CITY OF HUGHSON COMMUNITY DEVELOPMENT DEPARTMENT

Addendum Number 2

SANTA FE AVENUE RESURFACING PROJECT - PHASE II

The intent of this Addendum No. 2 is to add new bid items for Dig-Outs and Paving Fabric, show locations of Dig-Out areas on the plans, plus provide the specification for Dig-Outs and Paving Fabric, reducing AC from 0.30' to 0.20', delete sheet 3 of 7 from original plans and add Digout Plan sheets 1 & 2, and revise the Bid Schedule:

SHEET:	1
OF	2

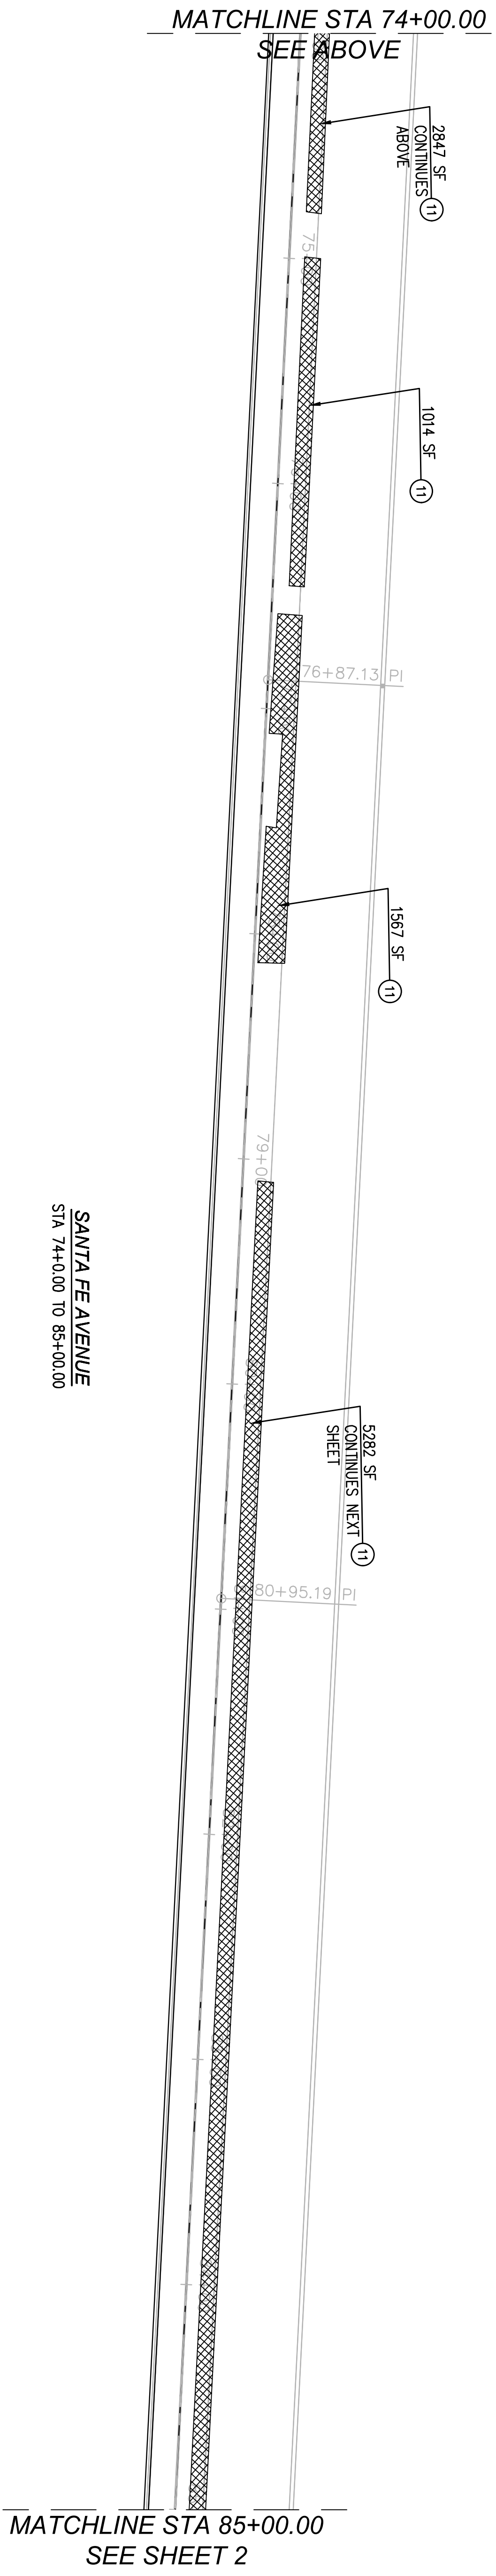
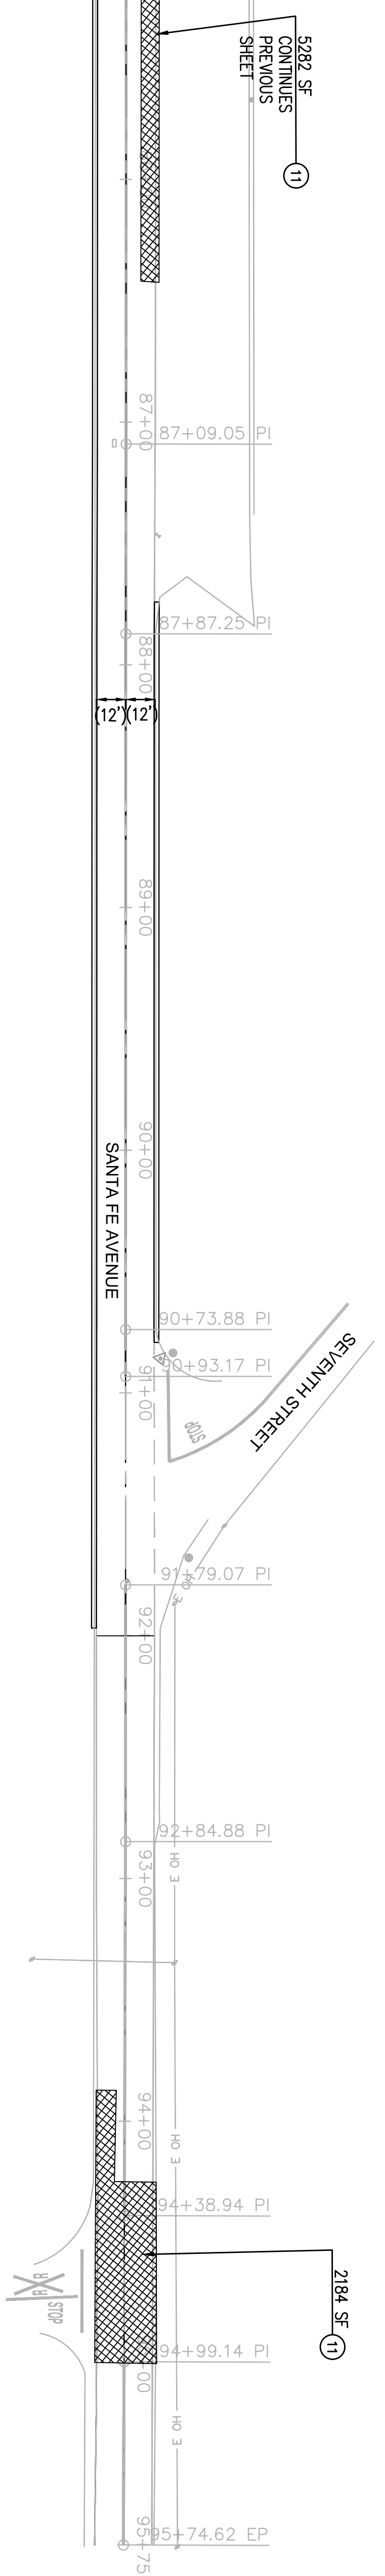
IV. Delete Sheet 3 from Original Plans. Adding DIGOUTS (Sheets 1 and 2):

This work involves the removal of existing roadway per dimensions and locations identified on the plans. Area to be removed will be reconstructed with aggregate base and hot mix asphalt.

Hot mix asphalt concrete for DIG-OUTS shall be ½” HMA Type A Max Medium and shall conform to the provisions in Section 39-2, "Hot Mix Asphalt," of the Standard Specifications.
